Access Compliance Report

Public Rights-of-Way

(Curb Ramps)

Intersection ID: 44760	Main Street: KINGS_PARADE_BV	Cross Street: OBAN_PASSAGE_DR	Location: SE
ADA ID: C8522D08544D	Ramp Type: BlendTrans1	Initial Pass/Fail: Fail	Overall Compliance: No
Severity Score: 8.75			
Codes/Mitigation Info/Possible Solution		Field Measurements/Component Compliance

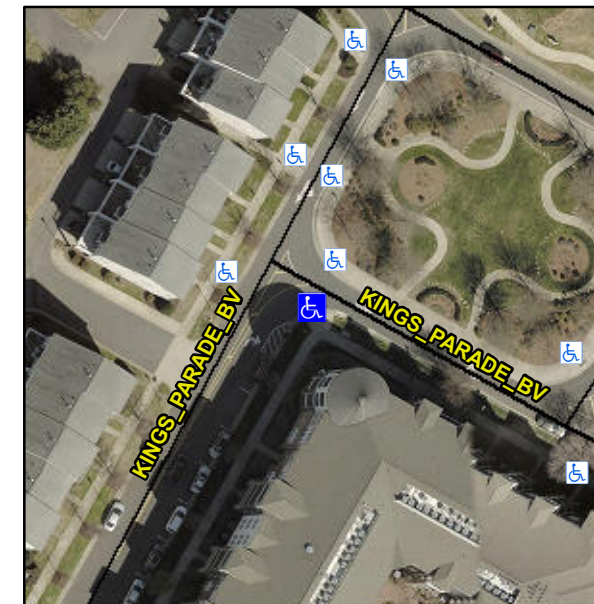
Not Found, R304.5.1

Compliance	Description	Data	Compliance	Description	Data
N/A	Ramp Length (in)	95.0	Yes	BlendTrans Slope (%)	4.0
No	Ramp Width (in)	45.5	Yes	BlendTrans XSlope (%)	1.9
N/A	Flare Type LT	N/A	N/A	Flare Type RT	N/A
N/A	Flare Slope LT (%)	N/A	N/A	Flare Slope RT (%)	N/A
N/A	Flare Traversable LT?	N/A	N/A	Flare Traversable RT?	N/A
N/A	Landing Length (in)	N/A	N/A	DWS Provided?	N/A
N/A	Landing Width (in)	N/A	N/A	DWS Contrast?	N/A
N/A	Landing Slope (%)	N/A	N/A	DWS Length (in)	N/A
N/A	Landing X Slope (%)	N/A	N/A	DWS Full Width?	N/A
N/A	Landing Curb? (Y/N)	N/A	N/A	DWS Offset (in)	N/A
N/A	Shared Landing?	N/A			
N/A	Gutter Ponding?	N/A	N/A	Gutter Slope (%)	N/A
N/A	Gutter Lip Ht (in)	N/A	N/A	Gutter X Slope (%)	N/A
N/A	Painted X Walk1?	No	N/A	Painted X Walk2?	No
	X Walk 1 Direction	To N		X Walk 2 Direction	To W
	X Walk 1 Width (in)	N/A		X Walk 2 Width (in)	N/A
	X Walk 1 Slope (%)	2.6		X Walk 2 Slope (%)	0.2
	X Walk 1 X Slope (%)	1.1		X Walk 2 X Slope (%)	2.1

N/A	Ramp inside XWalk1?	N/A	N/A	Ramp inside XWalk2?	N/A
	Road Slope (%)	3.1		Clear Space?	N/A
	Road X Slope (%)	1.1	N/A	Clear Space to XWalk (in)	N/A
N/A	Any Obstructions?	N/A	N/A	Storm Grate/Utility Hazard?	N/A
	Obstruction Type			Storm Grate/Utility Type	
		N/A			N/A
			Yes	Surface Condition? (G/P)	Good
			No	Curb Slope (%)	16.0

Remove & Replace Curb Ramp With Two New Directional Ramps or Equivalent.
